Supporting material for clause 85

Draft 1.1 comments

Chris Di Minico
MC Communications
cdiminico@ieee.org

Figure 85–X—Transmit test fixture at TP0

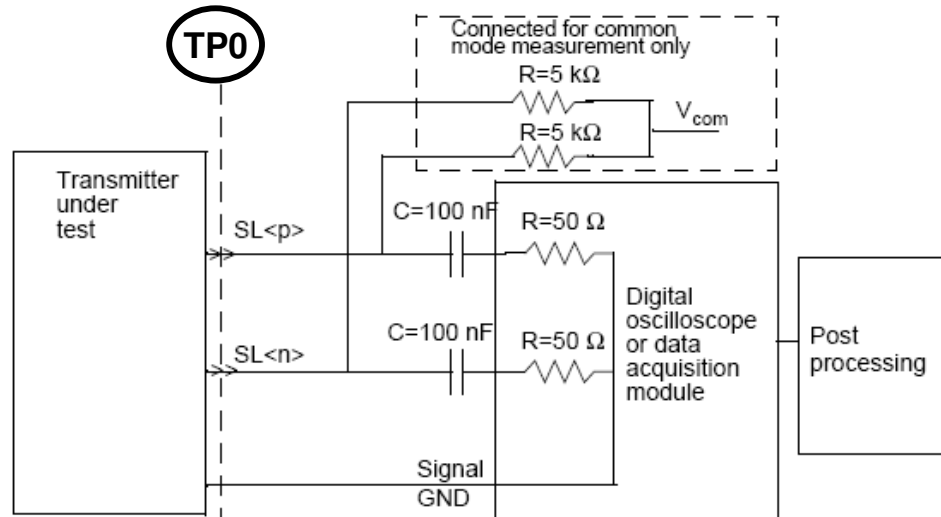
- Replace 85.8.3.1 Test fixtures with Figure 85–X—Transmit test fixture at TP0.

Table-85-X

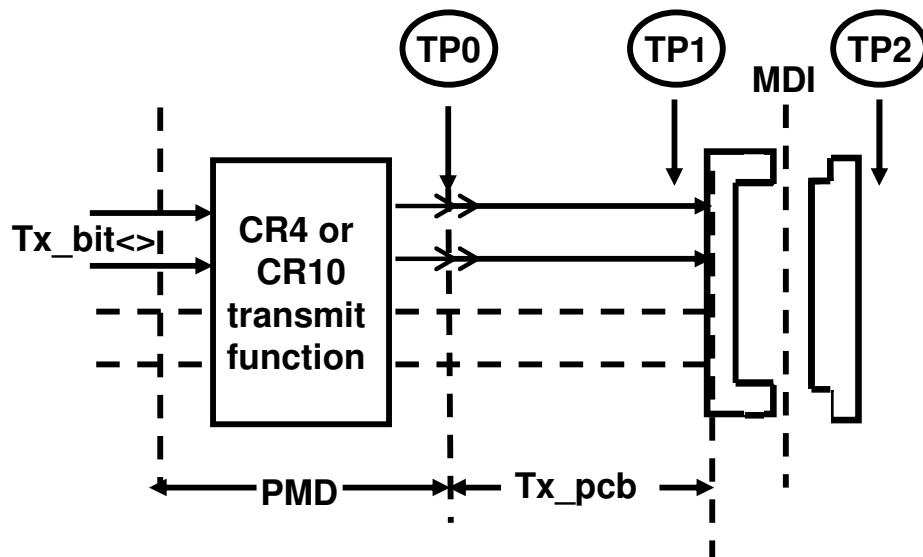
- Do we need to specify at TP2 in addition to TP0?

- What to specify?

- What are the values?

- Test fixture?

- Proposal to be provided prior to the meeting.

- Adjust applicable Table-85-4 transmitter specifications at TP0 to specify TP2.

802.3ba RL proposal and SFP+ 3.2

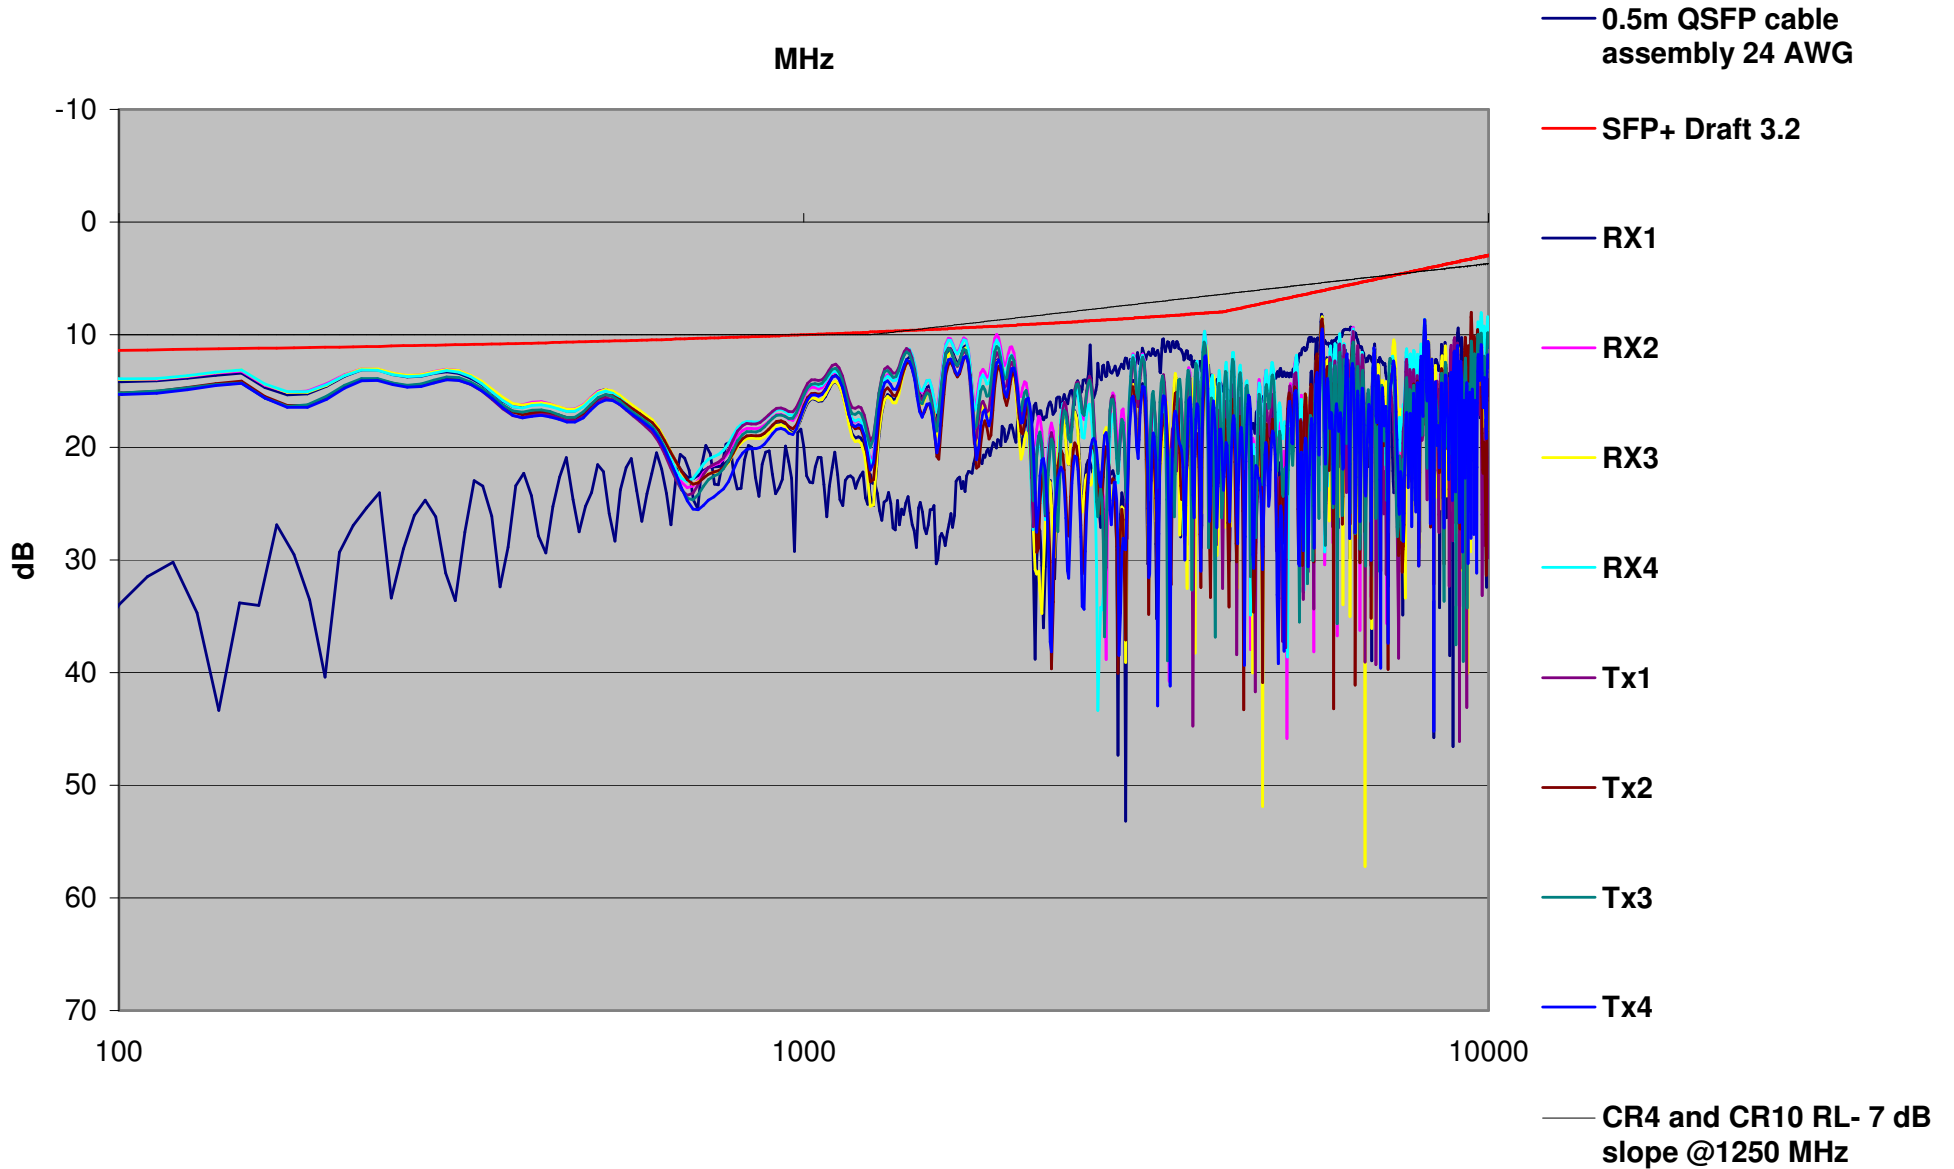
•Draft 1.1- comment

$$\text{ReturnLoss}(f) \geq 10$$

$$100 \text{ MHz} \leq f < 1250 \text{ MHz}$$

$$\text{ReturnLoss}(f) \geq 10 - 7 \times \log\left(\frac{f}{1250}\right)$$

$$1250 \text{ MHz} \leq f \leq 10000 \text{ MHz}$$

802.3ap ILD vs CR4 and CR10 ILD 0.5m and 10m cable assembly

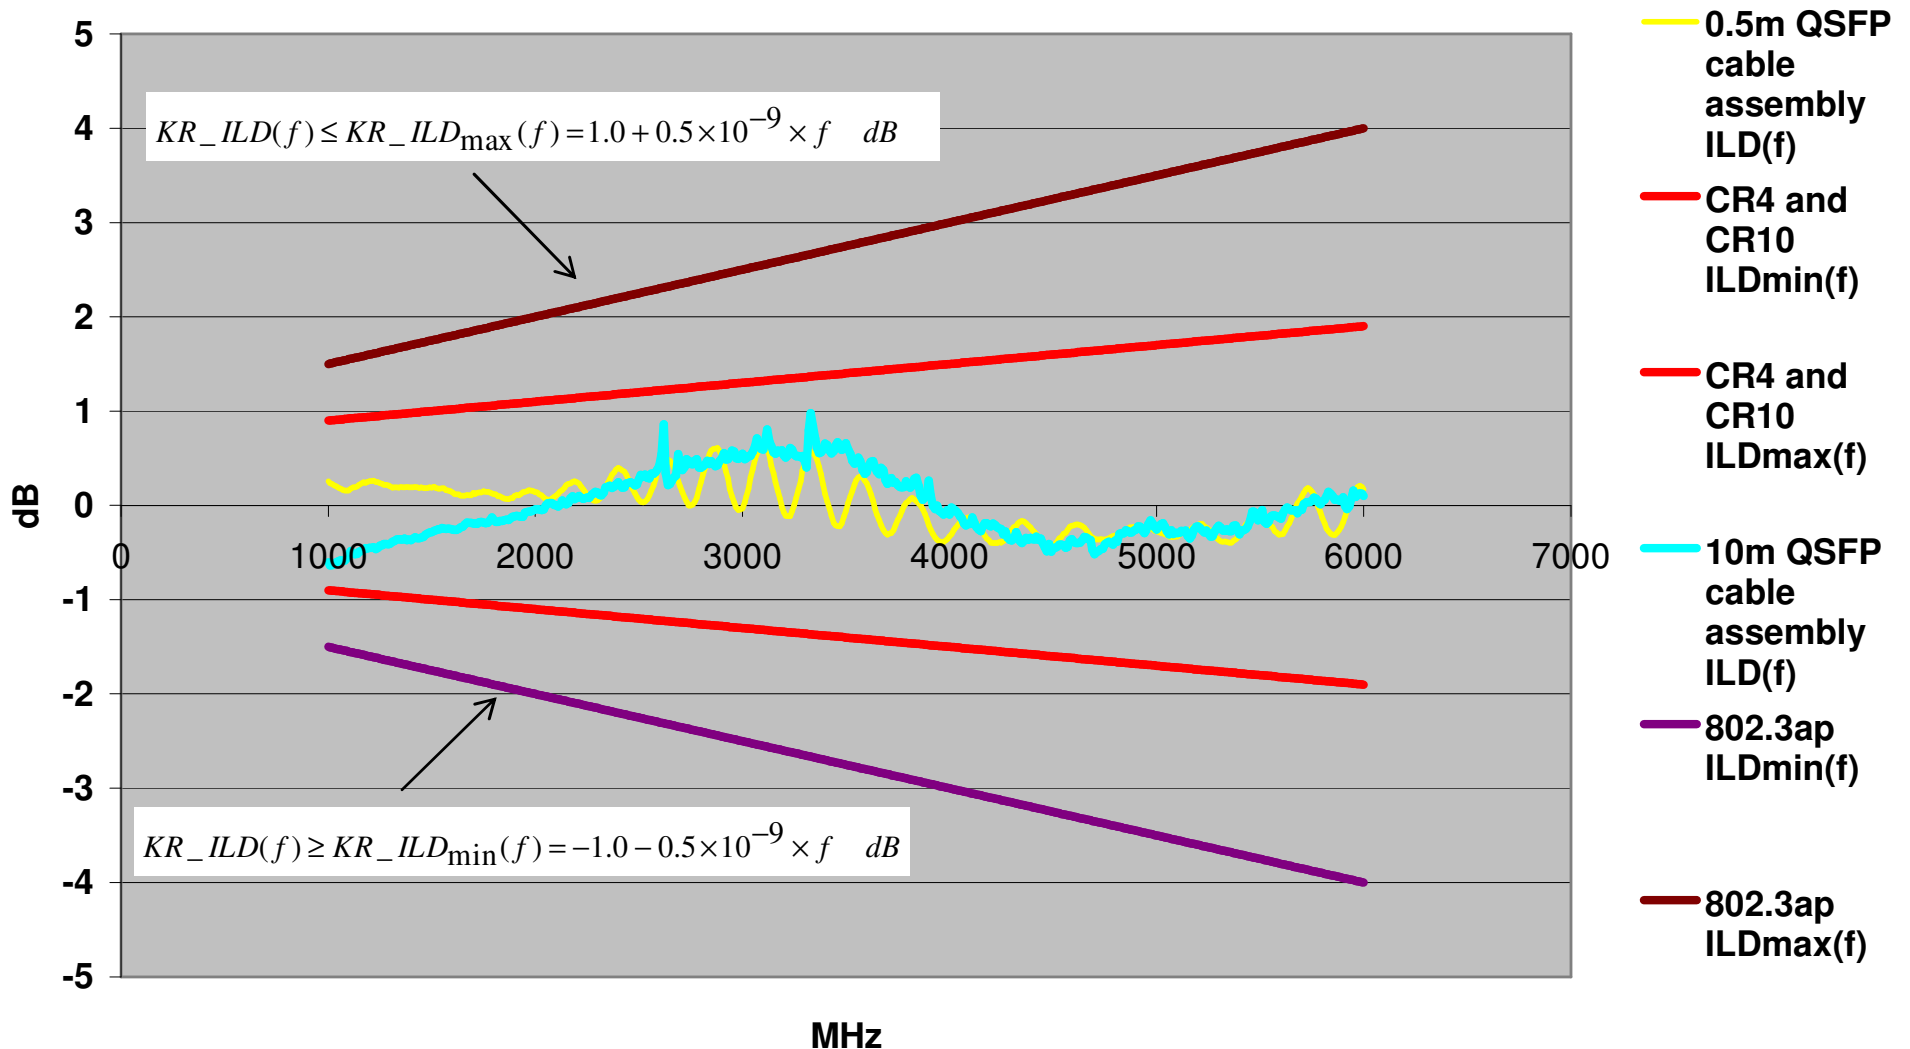
Add cable assembly ILD specifications to limit cable assembly ILD. Add TBD to equation as contributions from IL and power sum crosstalk to ICR under consideration.

The cable assembly insertion loss deviation is the difference between the cable insertion loss and the fitted insertion loss determined using Equation (85-x).

$$ILD(f) = IL(f) - IL_{fitted}(f) \quad (85-x)$$

The ILD shall be within the region bounded by the following equations:

$$ILD_{max} = 0.7(TBD) + 0.2(TBD) \cdot 10^{-9} \cdot (f \cdot 10^6) \quad TBD \text{ dB}$$

$$ILD_{min} = -0.7(TBD) - 0.2(TBD) \cdot 10^{-9} \cdot (f \cdot 10^6) \quad TBD \text{ dB}$$

$$1000 \text{ MHz} \leq f \leq 6000 \text{ MHz}$$
